Rezoning Application: PD 21-0557
Zoning Hearing Master Date: September 13, 2021
BOCC Land Use Meeting Date: November 9, 2021

RZ-PD 21-0557

PROJECT NAME: LAKEWOOD DRIVE SITE
SHEET TITLE: REZONING PLAN

TO: Zoning Technician, Development Services Department
REVIEWER: Richard Perez, AICP
PLANNING AREA: Seffner Mango

2.4 Proposed Site Plan (partial provided below for size and orientation purposes. See Section 8.0 for full site plan)

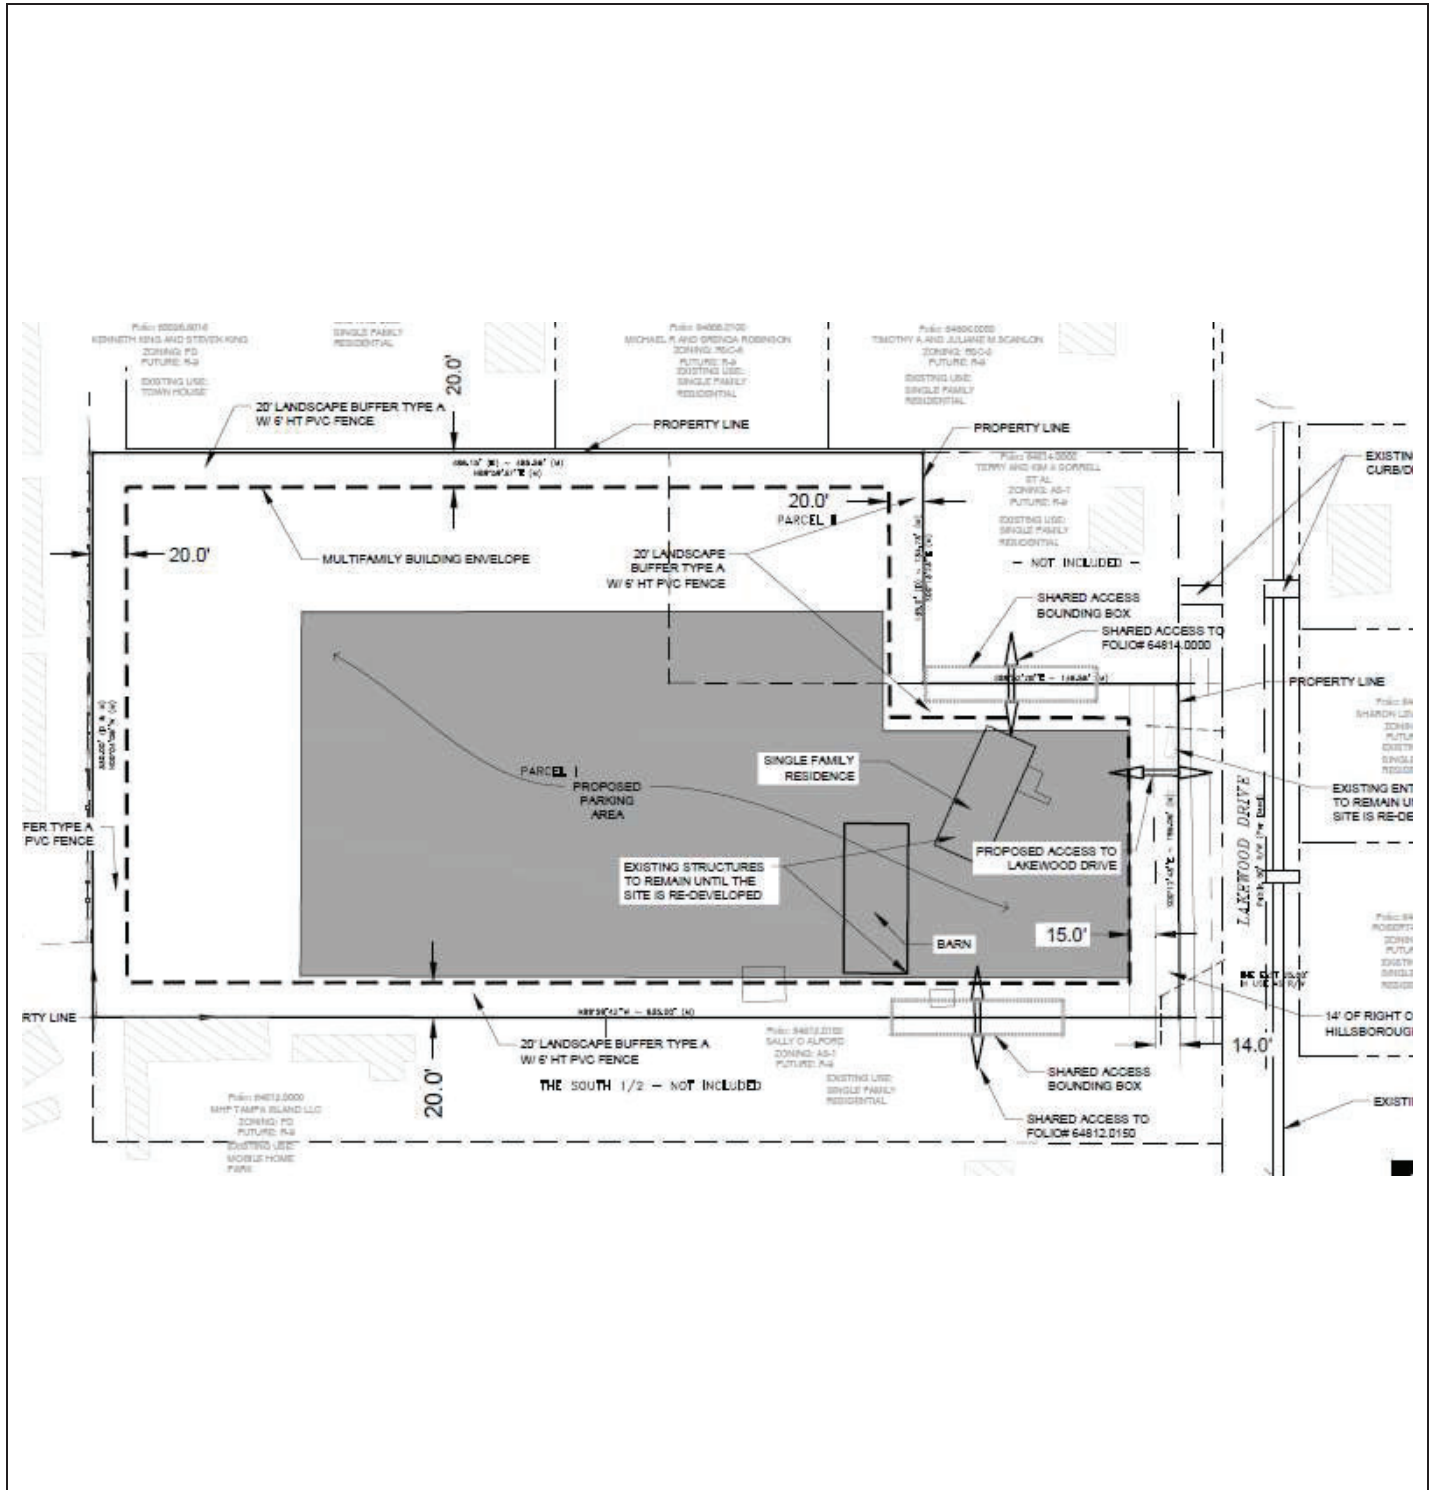
1. Prior to site plan certification, the applicant shall align the proposed access connection with the existing driveway to the east located on folio# 64838.0000.

2. Building and parking areas shall be developed where generally depicted on the site plan. Stormwater ponds locations shall be limited to within the multi-family building envelopes.

3. Multi-family buildings shall provide a minimum setback of 20 feet from all northern, western and southern PD boundaries. Multi-family buildings shall provide a minimum setback of 20 feet from folio 64814.0000. Multi-family buildings shall be located where depicted from Lakewood Drive.

4. A 20-foot wide buffer with screening shall be provided along the northern, western and southern PD boundaries, and along the west and south of folio 64814.0000, as depicted on the general site plan. Screening within this buffer shall consist of a 6-foot high PVC fence. Cross access stub-outs where depicted on the general site plan shall be permitted within any buffers.

7. The developer shall construct, prior to certificate of occupancy, a pedestrian and vehicular shared access facility to serve the adjacent properties to the north and south, folios# 64814.0000 and 64812.0150, anywhere within the bounding boxes depicted in the site plan consistent with the LDC.

9. Developer shall dedicate 14 feet of right-of-way along the project frontage.
10. Notwithstanding anything shown on the site plan, the developer shall provide ADA compliant sidewalk connections between principal building entrances, parking areas and access points.

SHEET TITLE:
REZONING PLAN

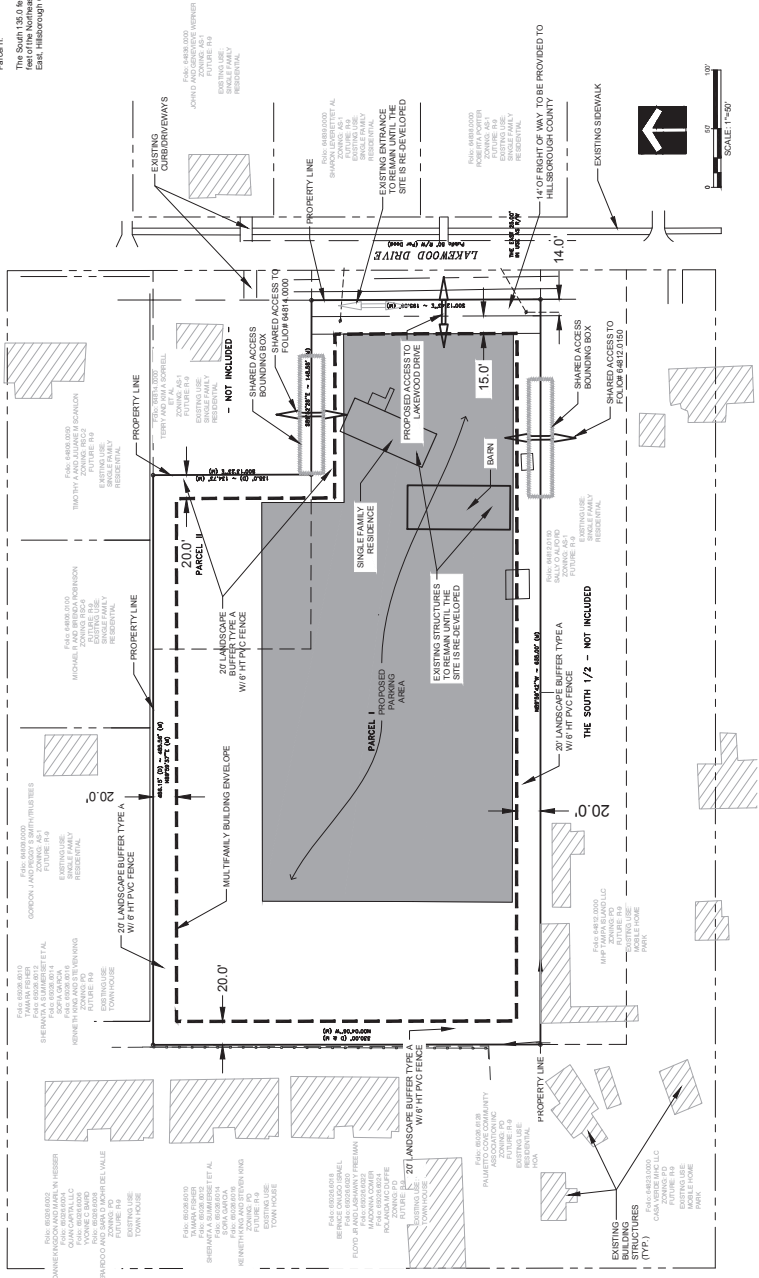
- Prior to site plan certification, the applicant shall align the proposed access connection with the existing driveway to the east located on folio# 64838.0000.

To address the substandard right of way width, the applicant has proffered to dedicate 14 feet along the project frontage as shown on the PD site plan.

The proposed site plan provides one (1) access connection on Lakewood Drive.
